BCUC INQUIRY RESPECTING SITE C

Re: British Columbia Hydro and Power Authority – British Columbia Utilities Commission Inquiry Respecting Site C – Project No. 1598922 – Final Report

Report errata

1.1 Math Error regarding Mid-C price forecasts used in the Site C Calculator

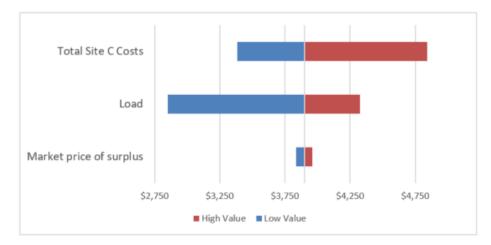
The Mid C price forecasts used in the Site C unit energy cost (UEC) Calculator are in real terms and should have been inflated to nominal terms.

The Panel confirms that the graph upon which the Mid C price forecasts were derived are in real F\$2018 and therefore should be inflated to nominal. In the alternative portfolio spreadsheets, these same price forecasts were inflated to nominal.

By correcting the Mid-C price forecasts to nominal in the Site C UEC calculator, we find that the rate impact (NPV) from Site C under the **low load case** is \$336 million lower, at \$2,852 million instead of \$3,188. Under the **mid load case**, the rate impact from Site C is \$68 million, at \$3,901 million instead of \$3,969 million. There is no impact on the high load case as there is no surplus energy in that scenario.
